**JSCC WORKFORCE DEVELOPMENT BUILDING  
SCO # 22-24540-02A**

**CMAR ADDENDUM NO. 3 (CM3)**

ISSUED ON: FEBRUARY 19, 2025

## Monteith Construction RFI Log

**2**  
**A6.0** Enlarged Plan @ Men's Toilet Room  
Scale: 3/8" = 1'-0"  
NOTE: SEE S2.01 FOR 2" DEPRESSED SLAB LOCATIONS.  
REFER TO PLUMBING DRAWINGS FOR FLOOR DRAINS.  
SLOPE SLAB TO DRAIN @ 1/8"FT AS SHOWN.

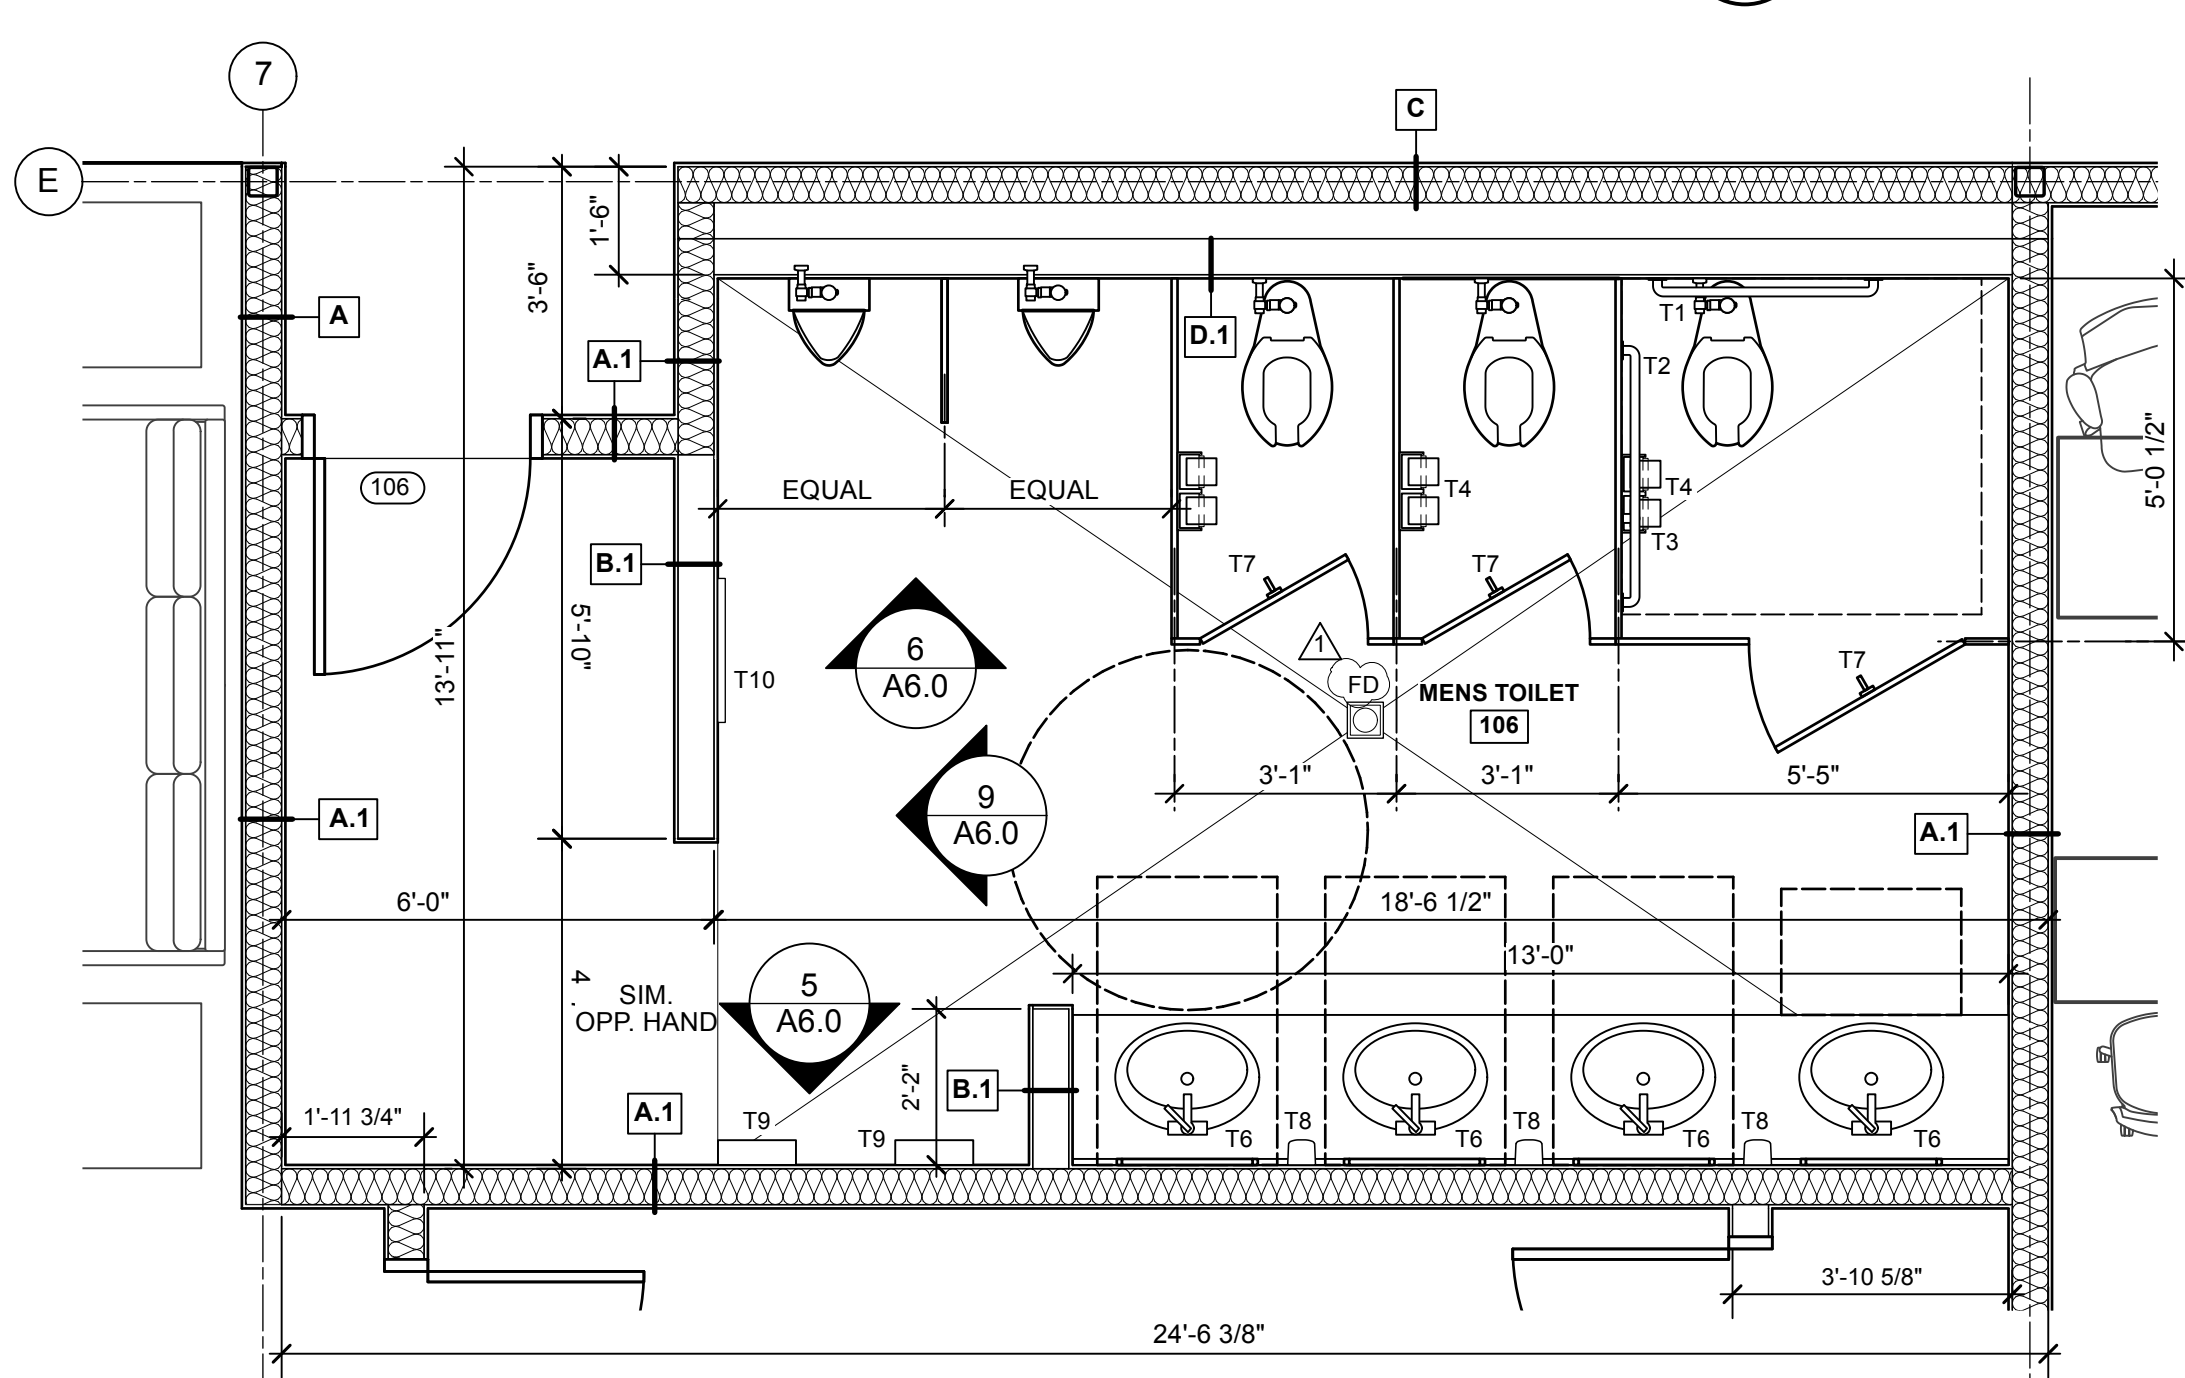
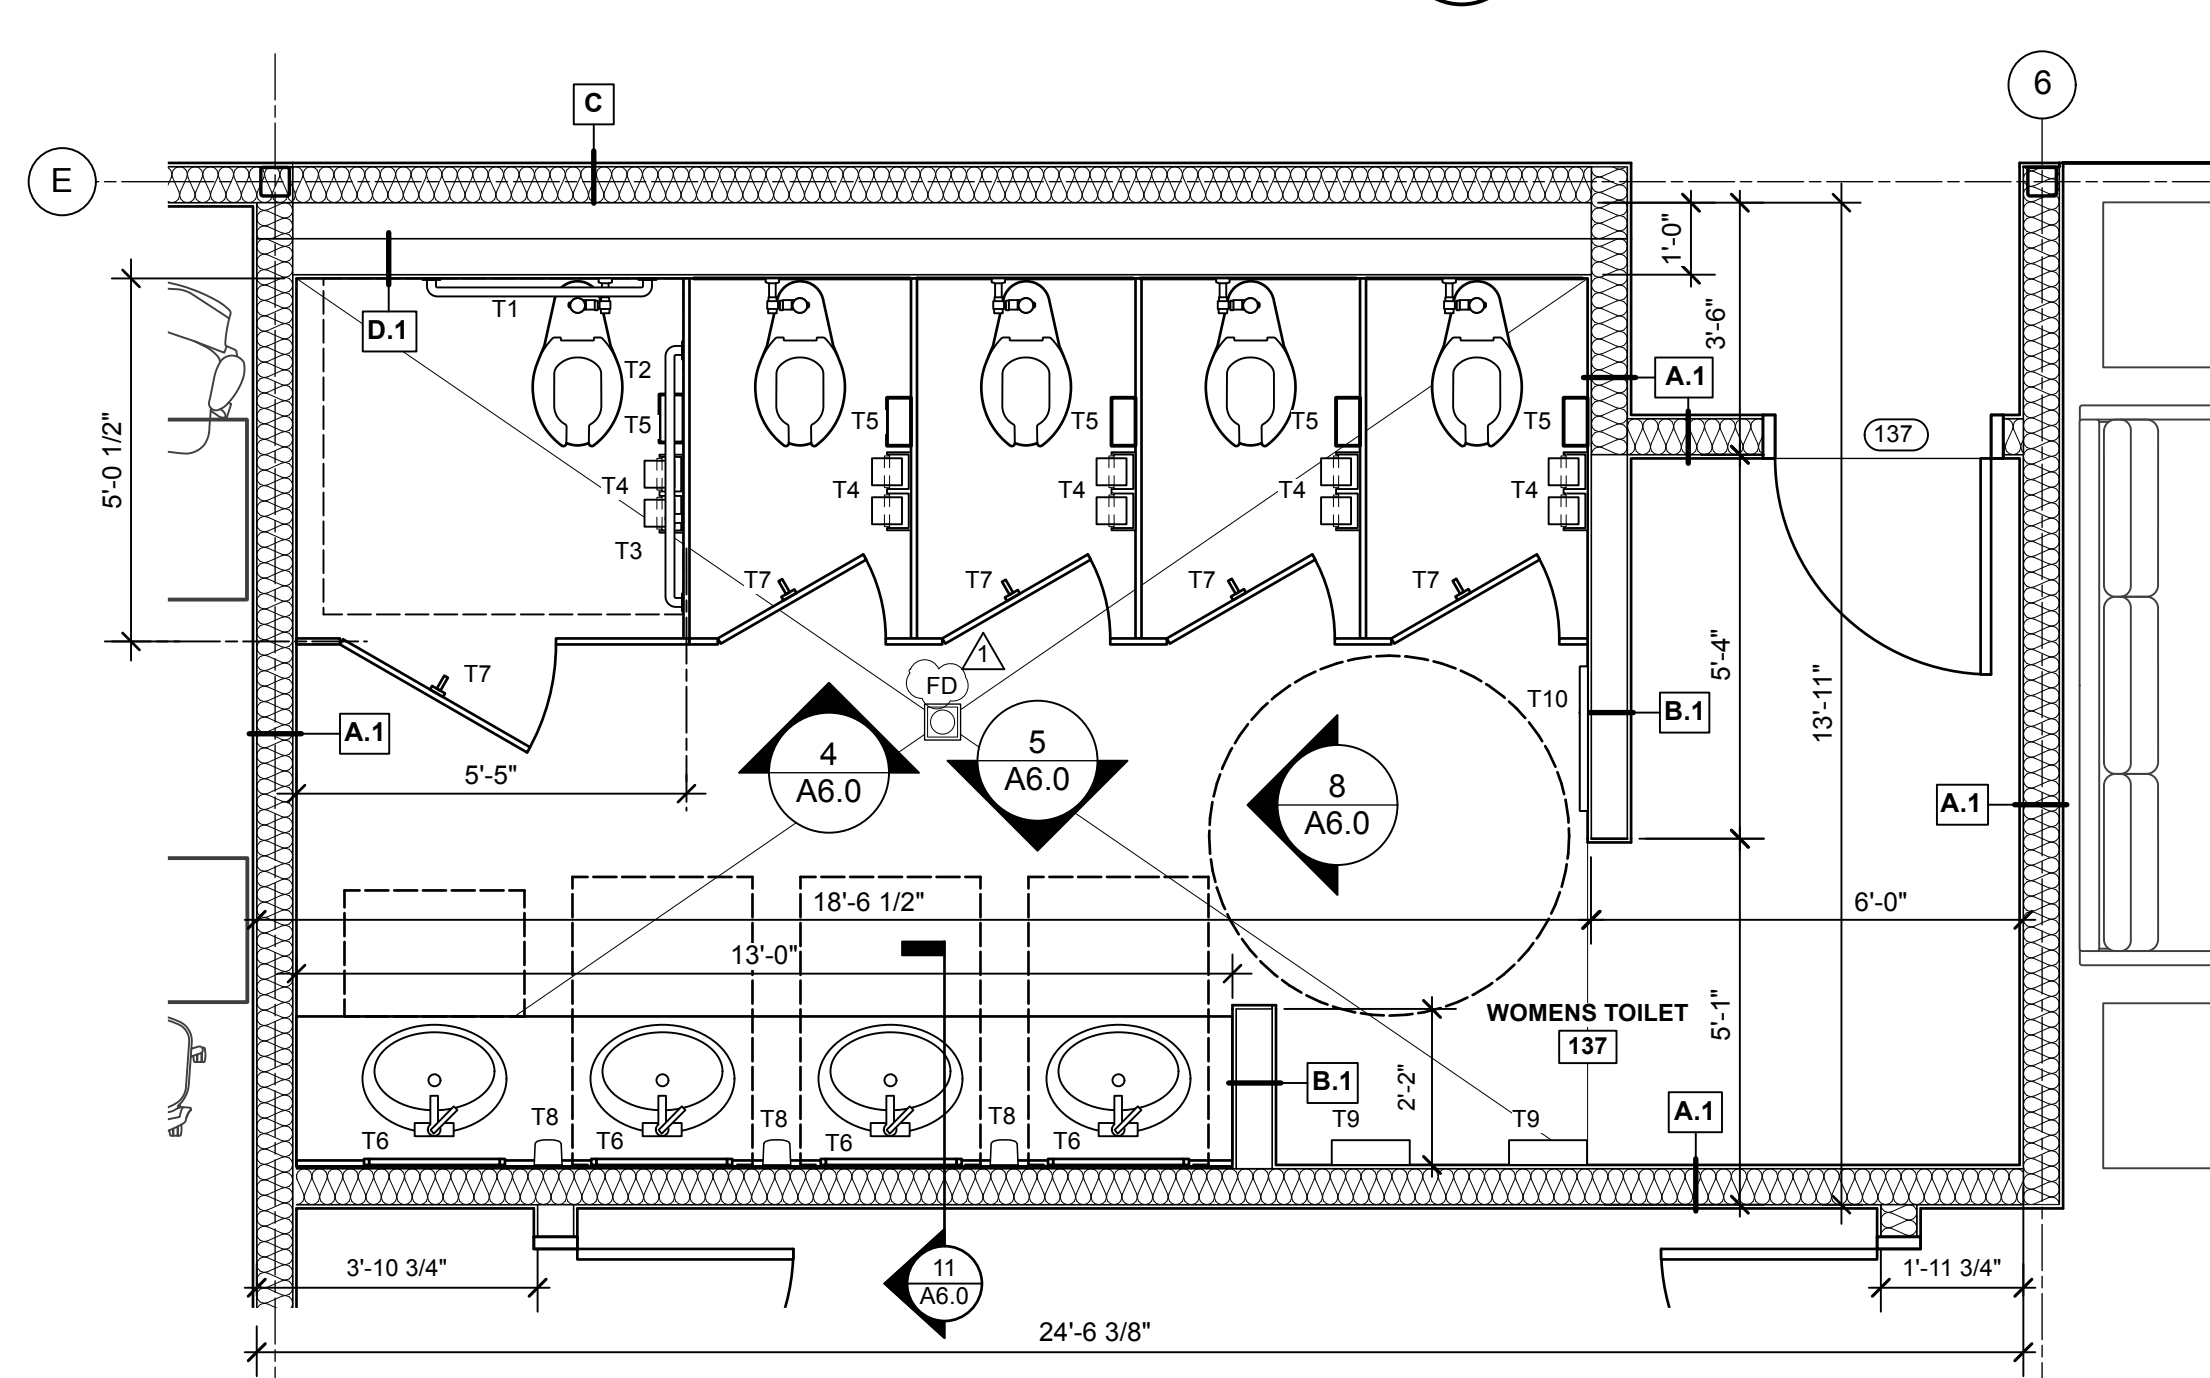
**Item 19                    Drawings A6.0, A7.0 and S2.01 - Revisions (RFI #58)**

- Item 27      Drawings A6.0 - Clarification (RFI #80)**
- Notes have been added to drawing A6.0 referring to wall tile. Revised drawing A6.0 is included as **Attachment #5**.

Drawings have been revised to show slab depressions for rooms 119, 124, 106, and 137. Tile finish has been revised in the finish schedule. Revised drawings are included as **Attachments #5, #6, and #7**.

- Item 29      Drawings A6.0, A7.0 and S2.01 - Revisions (RFI #82)**
- Drawings have been revised to show slab depressions for rooms 119, 124, 106, and 137. Tile finish has been revised in the finish schedule. Revised drawings are included as **Attachments #5, #6, and #7**.

REV.	DATE	DESCRIPTION
1	2/18/2025	ADDENDUM #5

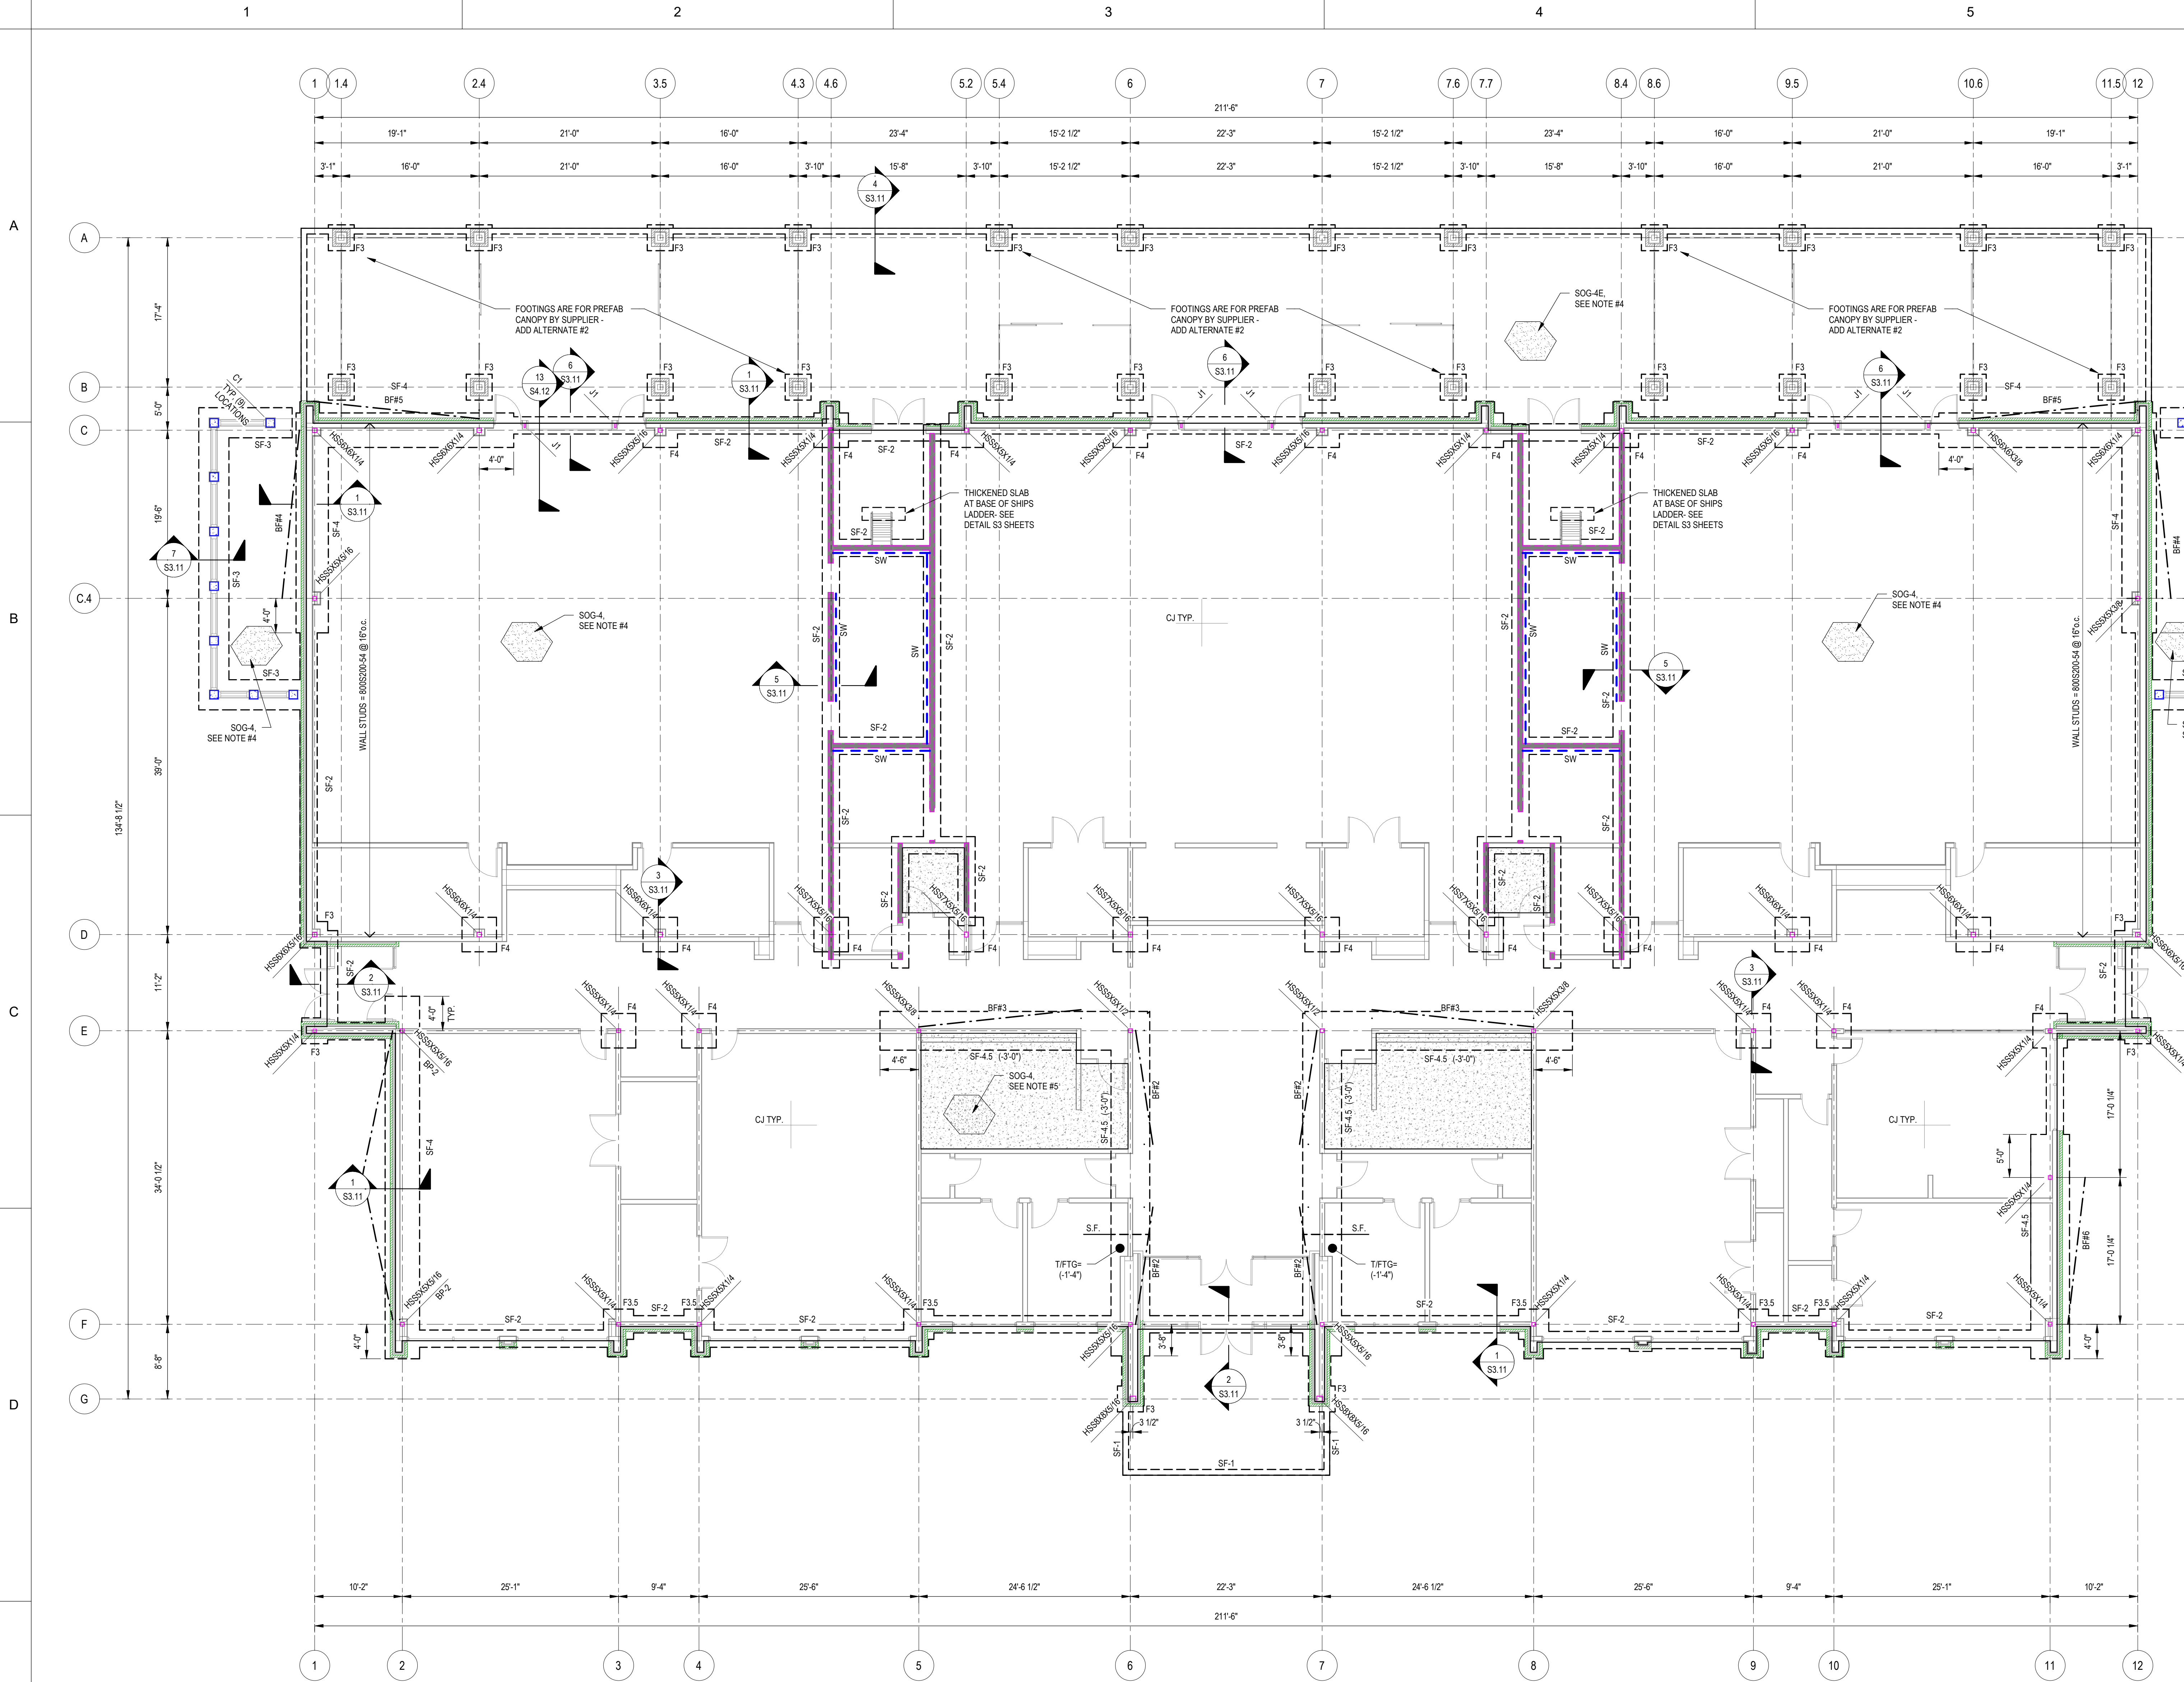
- Item 23      Drawings A7.0 - Clarification (RFI #72)**
- Wall base for rooms 114, 116, 120, 122, 127, and 129 has been revised to RBBS-1. Wall base to be included in the base bid. Revised drawing A7.0 is included as **Attachment #6**.

- Item 33      Drawing A7.0 - Clarification (RFI #89)**
- Wall Finishes called out in the finish schedule are for full height of the wall unless noted otherwise. Revised drawing A7.0 is included as **Attachment #6**.

- Item 36                    Drawings A7.0 - Clarification (RFI #96)**
- Polished concrete is Grade 2, Class 2. Revised drawing A7.0 is included as **Attachment #6**.

- Item 40                    Drawing A7.0 – Revisions**
- The finish schedule has been revised on sheet A7.0 to coordinate with owner review comments in the classrooms and offices. Revised drawing A7.0 is included as **Attachment #6**.
